# AT&T - BJ'S RESTAURANTS, INC

3703 9TH ST SW PUYALLUP, WA 98373

JB# 985709

PROPOSED AERIAL & UNDERGROUND FIBER INSTALLATION

**SITE PLAN - 1**

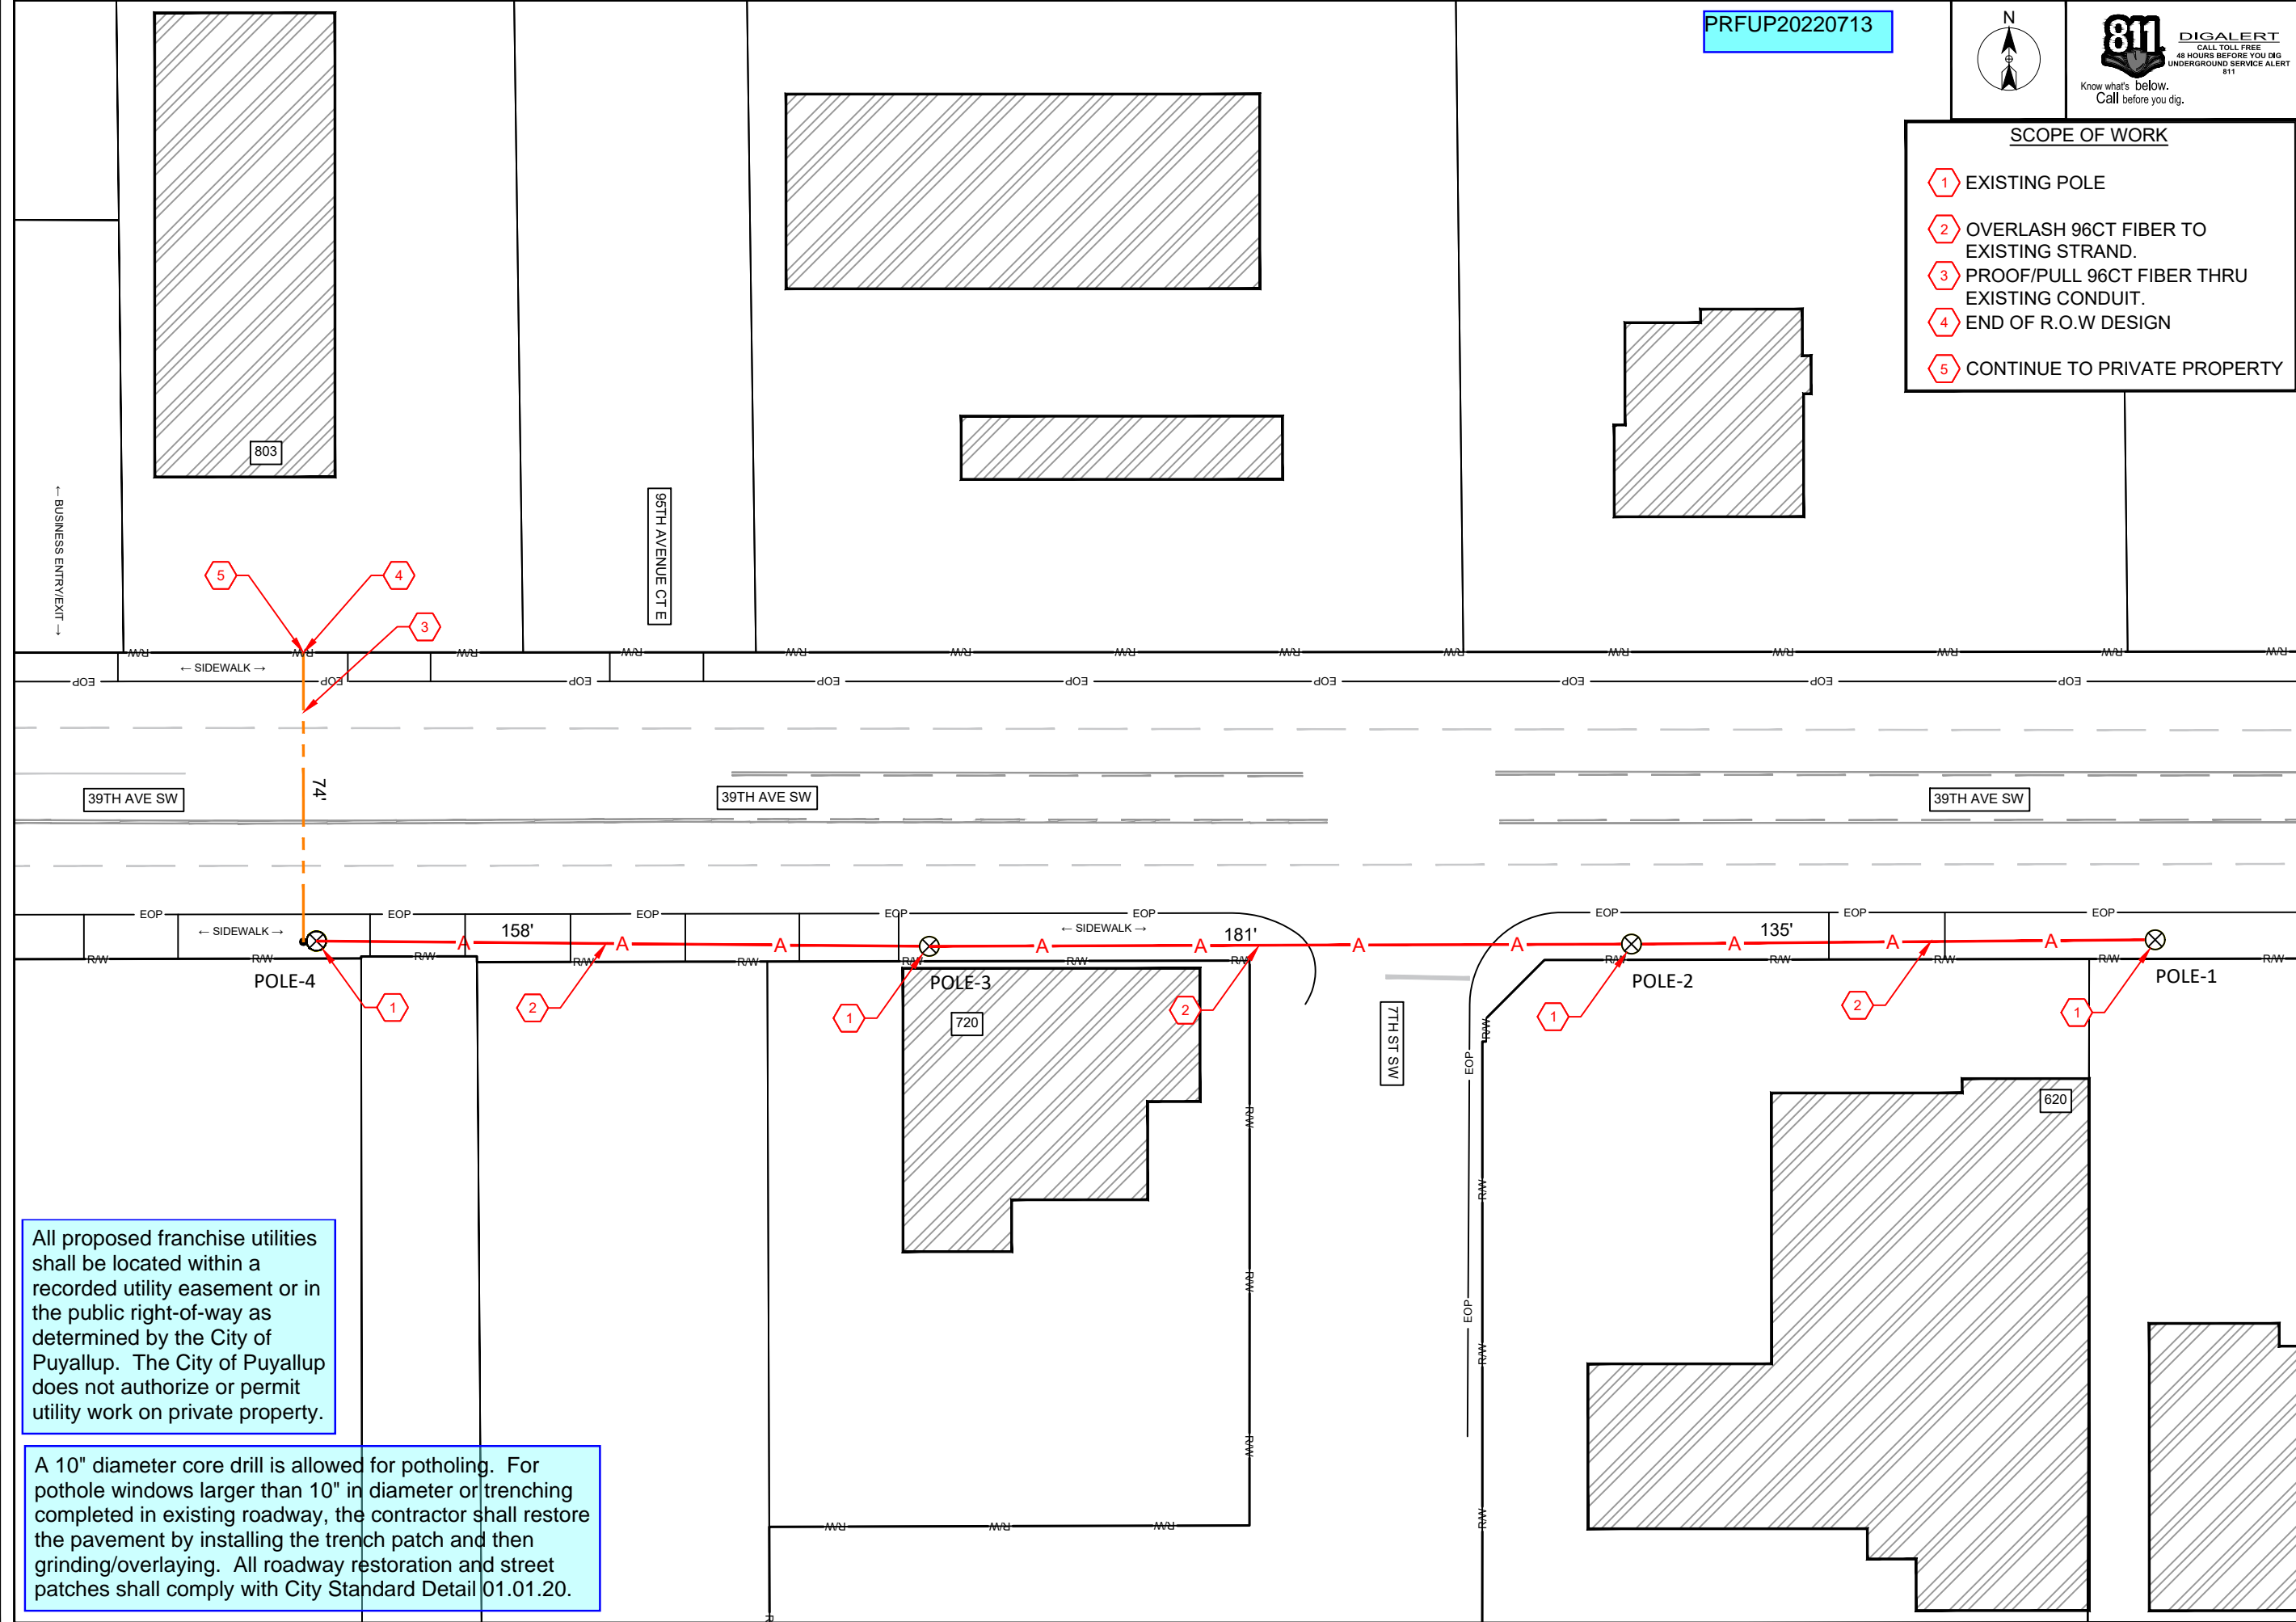
All proposed franchise utilities shall be located within a recorded utility easement or in the public right-of-way as determined by the City of Puyallup. The City of Puyallup does not authorize or permit utility work on private property.

A 10" diameter core drill is allowed for potholing. For pothole windows larger than 10" in diameter or trenching completed in existing roadway, the contractor shall restore the pavement by installing the trench patch and then grinding/overlaying. All roadway restoration and street patches shall comply with City Standard Detail 01.01.20.
